42 Southwood Lane, N6 5EB

Response to queries from Conservation Officer

Structural Inspection and Assessment 24th March 2023 - Notes

ROOF TIMBER CONDITION INVESTIGATION

Front elevation

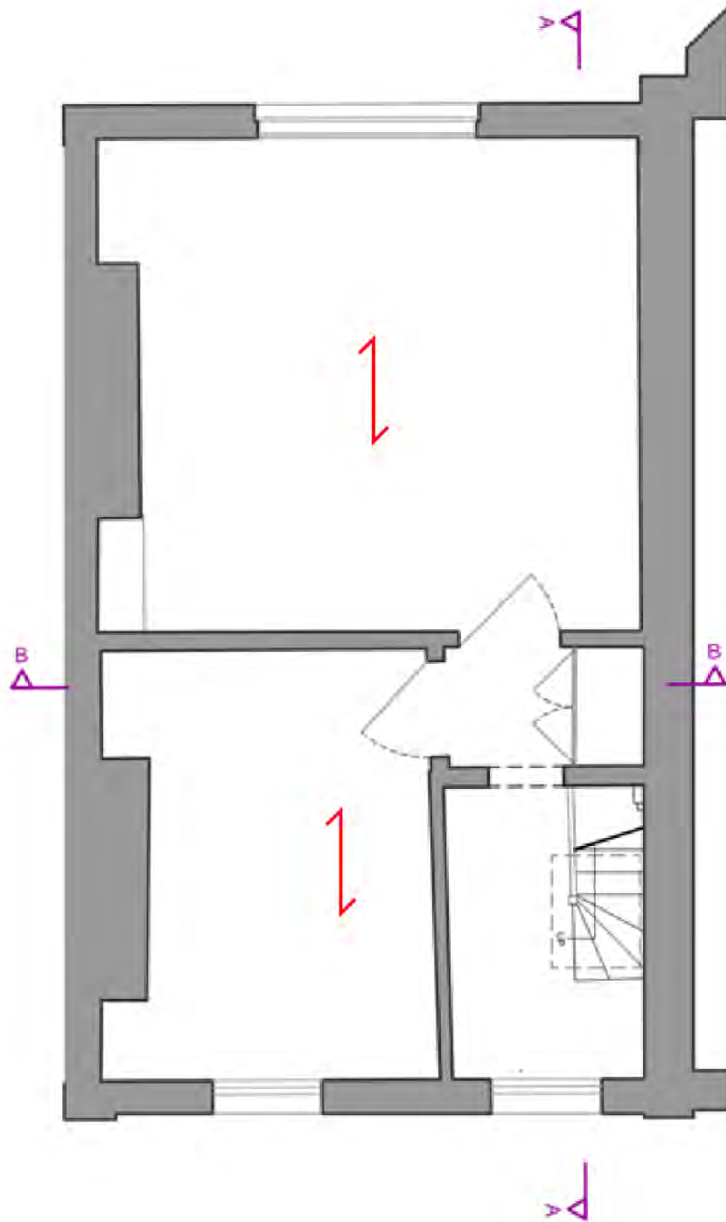
Views of front elevation - Front chimney stack on left hand side (LHS) has significant lean inwards (approx 4-5"). Front elevation shows signs of cracking which suggest historic and recent settlement at foundation level.

The leaning chimney stack is unstable and should be carefully taken down, the bricks set to one side and the stack rebuilt in lime mortar. Preferably, this should be done once the building is scaffolded and a temporary roof is in place. As the stack is on the party wall, the works should be detailed and agreed with the Party Wall Surveyor. As the roof structure is likely to be contributing to the stability of the stack, it should be taken down before any roof works are commenced.

Views of ceiling and roof structure at 2nd floor level: front wall LHS

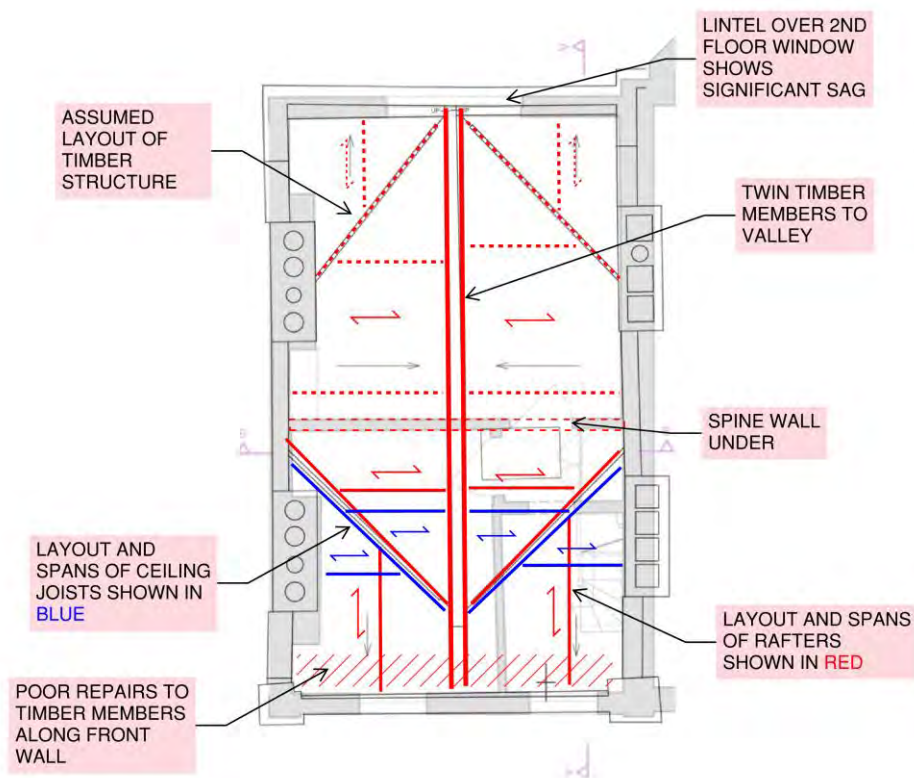
Views of ceiling and roof structure at 2nd floor level:

Poor splices.

Rafters and ceiling joists look undersized for spans. Timber support/connections at wall look poor and some have slipped.

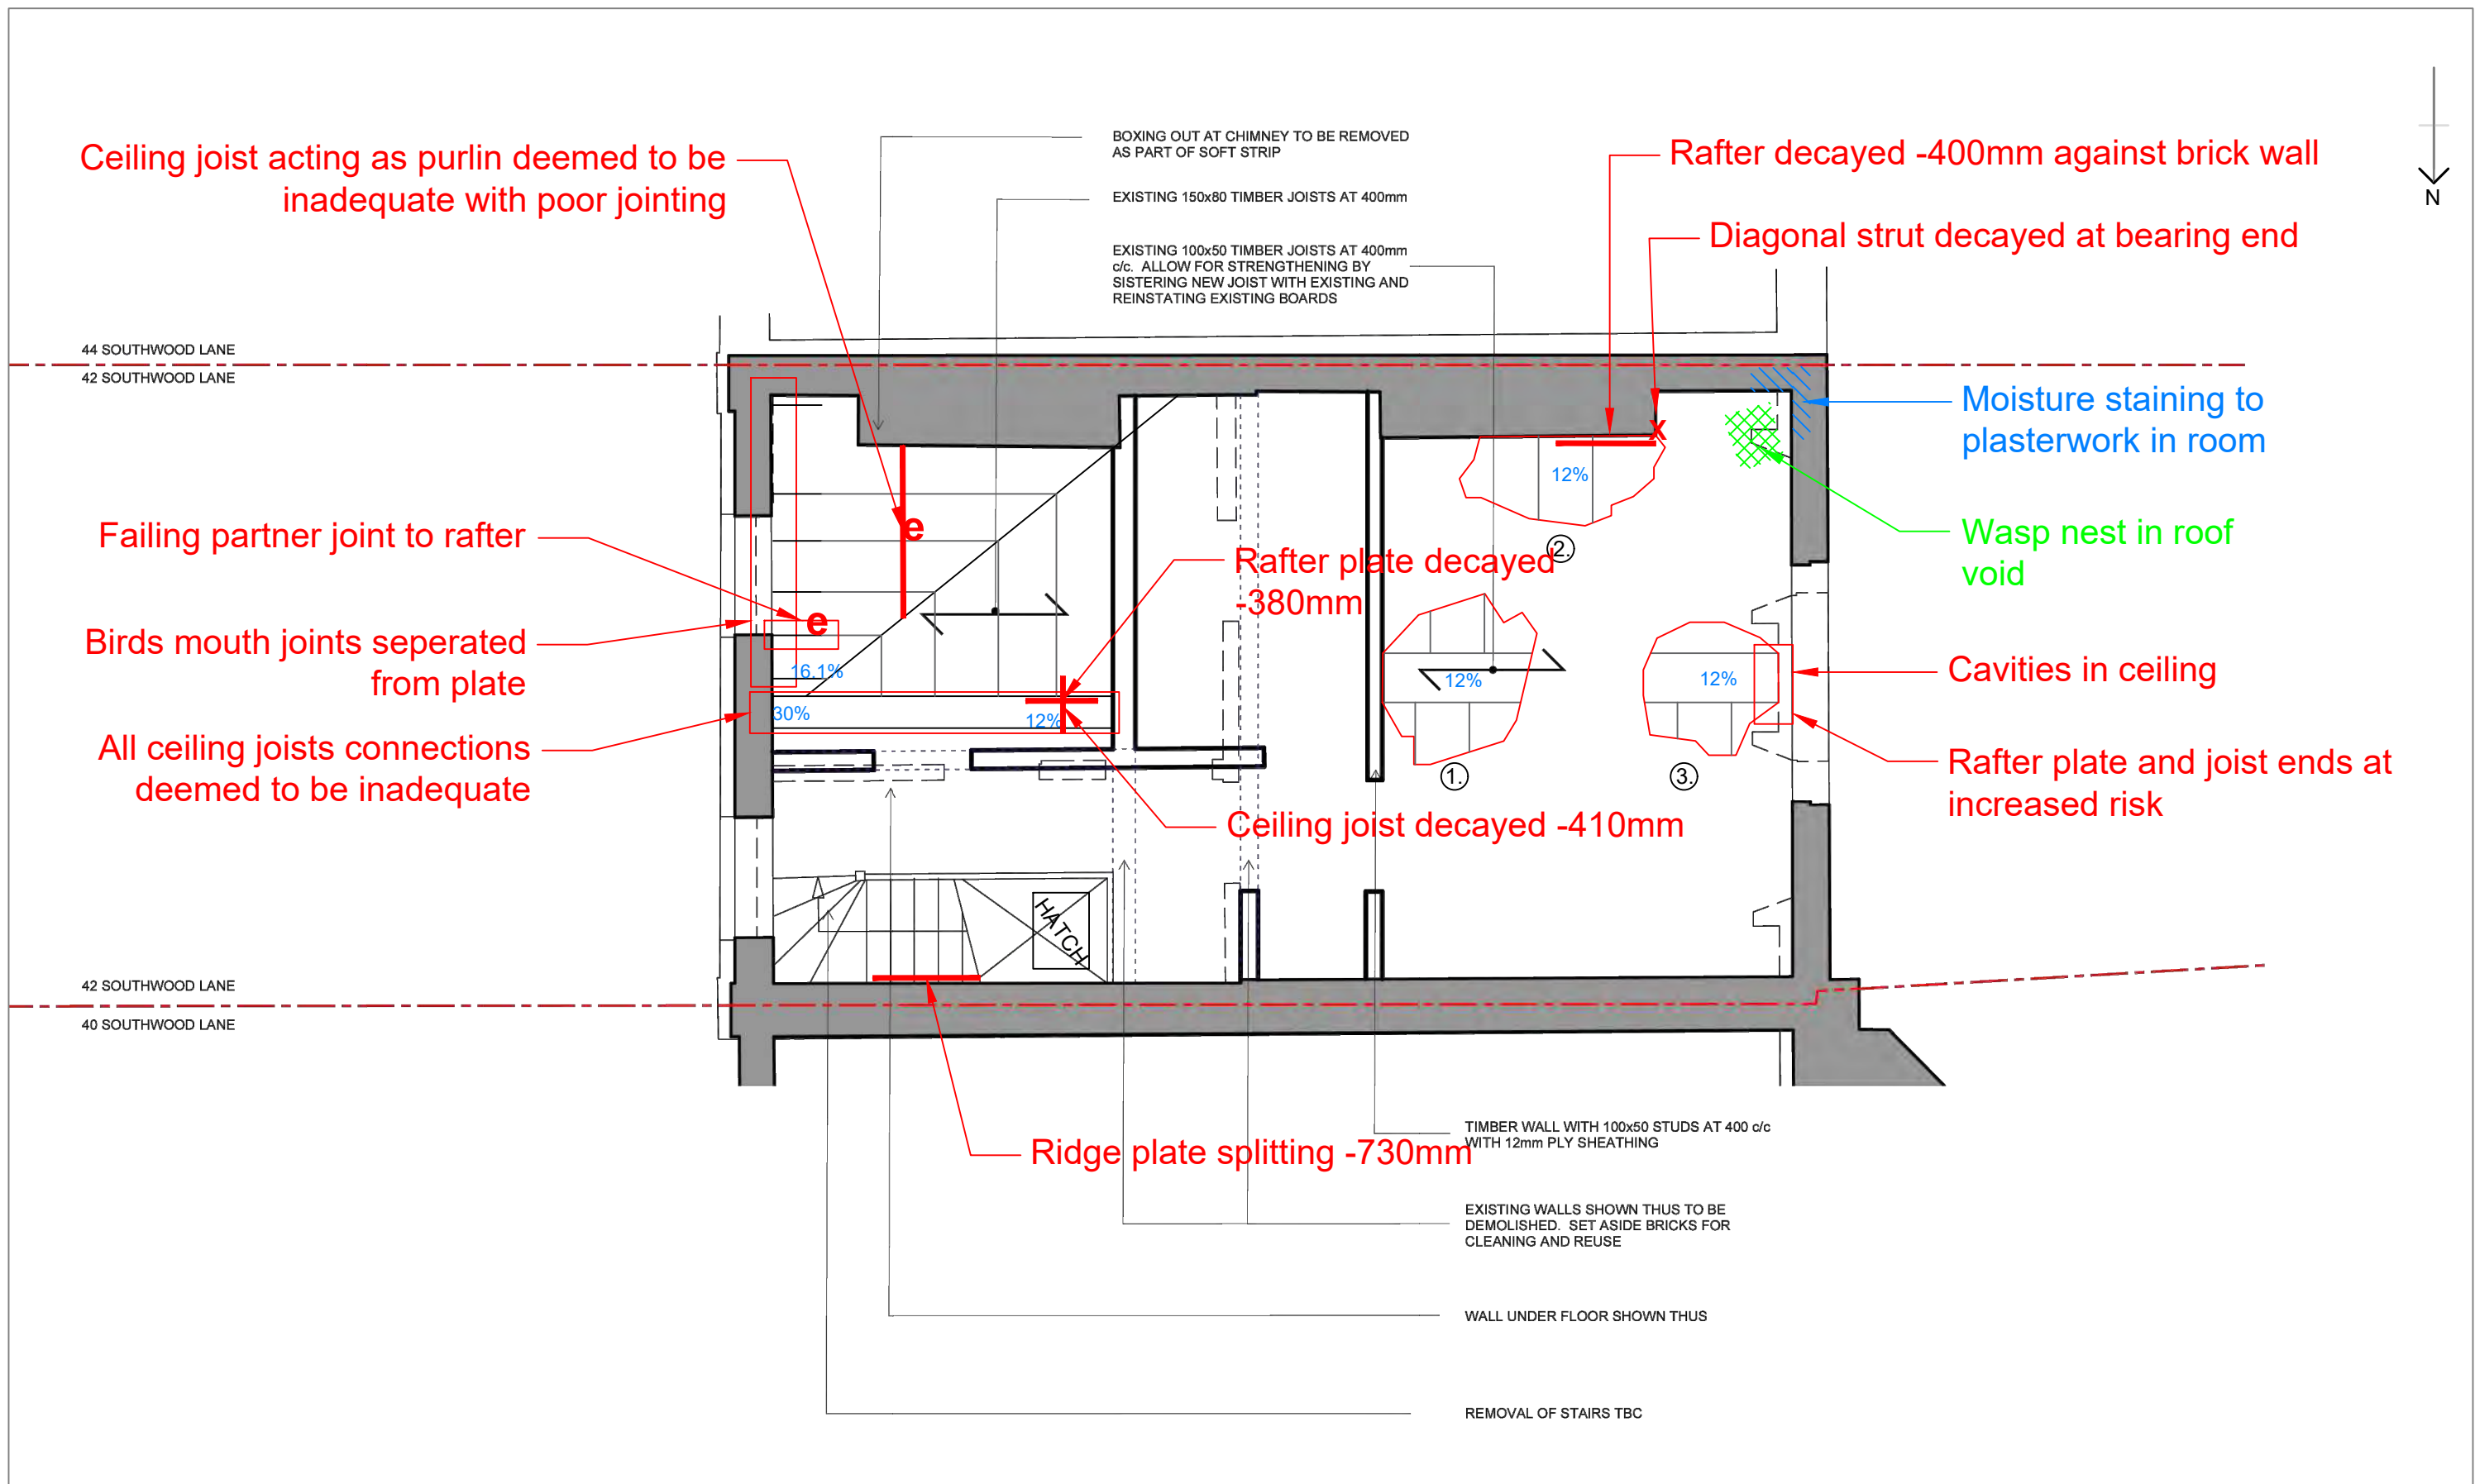
Internal, roof void; showing the lower section of a common rafter forming the north pitch of the roof structure. Note that recent partner repairs were identified

Internal, roof void; showing the presence of a contemporary hanger embedded into the north wall within the roof void, used to support the bearing end of a length of purlin that had likely been a recent installation during previous refurbishment works
